Technical Bulletin

Bulletin Number: 367 Revision Number: R-01

SUBJECT: MARS, MAKA, AND BILLTRON DOLLAR BILL VALIDATOR MOUNTING

REASON: Sequencer Interference

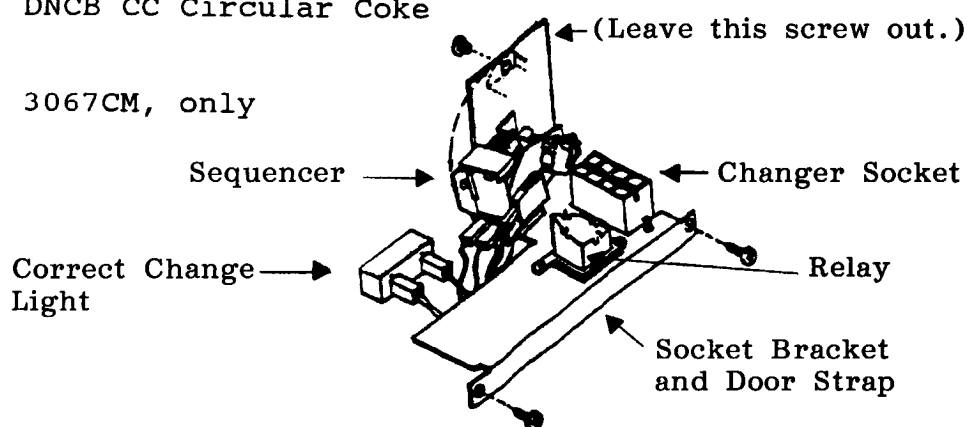
The following instructions are to be used when installing a Mars, Maka or Billtron Validator on any Coca-Cola CC vender that was manufactured on production run 3067.60 only. The sequencer interferes with the installation of the above validator and must be slightly relocated.

1. Unplug the vender.
2. Unplug the two (2) wires connected to the Correct Change Light.
3. Remove the two (2) screws holding the Socket Bracket to the door frame and vertical bulkhead.
4. Pull the bracket out of the door.
5. Remove the screw from the top of the bracket holding the sequencer and rotate the sequencer as per the drawing above.
6. Tighten the remaining screw holding the sequencer on the bracket.
7. Re-install the bracket in the door using the two (2) screws removed earlier.
8. Plug in the two (2) wires to the Correct Change Light.
9. Plug in the vender.
